**RE: DA/1950/2017 - SENIORS HOUSING - RESIDENTIAL CARE FACILITY
LOT 1938 DP 704459
120 REDHEAD ROAD, REDHEAD NSW 2290
REQUEST FOR ADDITIONAL INFORMATION**

I refer to Council's letter dated 21 December 2017 requesting additional information relating to DA/1950/2017 for proposed additions to a residential care facility.

Figure 3. Tetratheca juncea records and survey tracks.

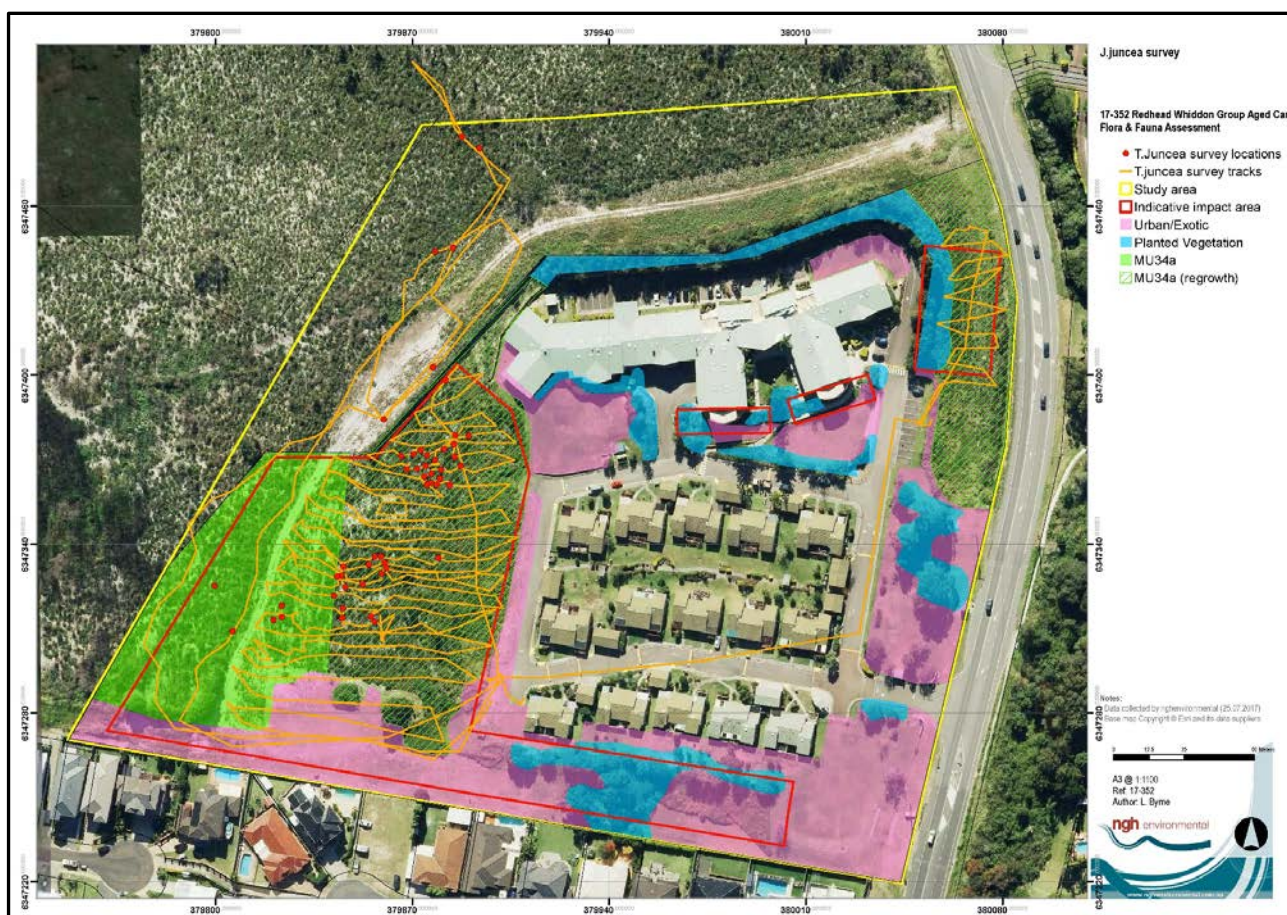
Clarification regarding survey effort is requested as outlined above. It is also requested that the ecological consultant provide:

- A clear plan overlying the development footprint including earthworks and asset protection zone, with T. juncea records at the site.
- A response to the significant impact criteria contained in Table 7 of Council's Tetratheca juncea Planning and Management Guidelines.

Targeted Tetratheca juncea flora surveys were conducted on the 28th September 2017 using parallel belt transects spaced at 4-5m, in accordance with the EPBC referral guidelines (SEWPaC 2011). Recorded locations of Tetratheca juncea and survey tracks are provided in **Figure 3**.

Areas within the site that contain *Tetratheca juncea*, that are outside of the identified impact areas are to be demarcated and protected. This is shown in the Landscape Design Package.

Although the loss of *Tetratheca juncea* is not considered as being significant, as the loss of individuals is greater than 75% of those within the proposed work area is unavoidable, Lake Macquarie *Tetratheca juncea* guidelines determine that an offset site is required.

The assessment identified that the loss of 65 individuals of *Tetratheca juncea* would require that 195 credits be secured utilising an offset option listed above (at a 3:1 ratio).

Figure 5. Section CC (North – South).

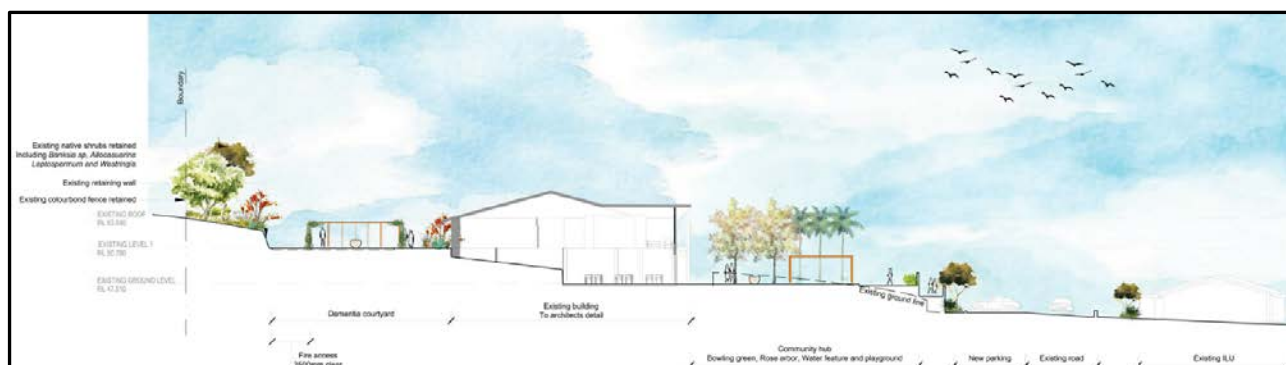
The proposed development includes retaining of earthworks up to 5 metres deep. Details of the proposed retaining system and associated aesthetic impacts are requested.

Opus have prepared an amended civil design package, included in **Attachment G**. The plans show the location of retaining walls proposed for the development. Specific detail relating to retaining wall construction is provided in **Attachment H**.

The Landscape Design Package, included in **Attachment B**, includes section drawings demonstrating how the retaining walls will be incorporated into the overall landscape design. Extracts are shown in **Figure 5** and **Figure 6**.
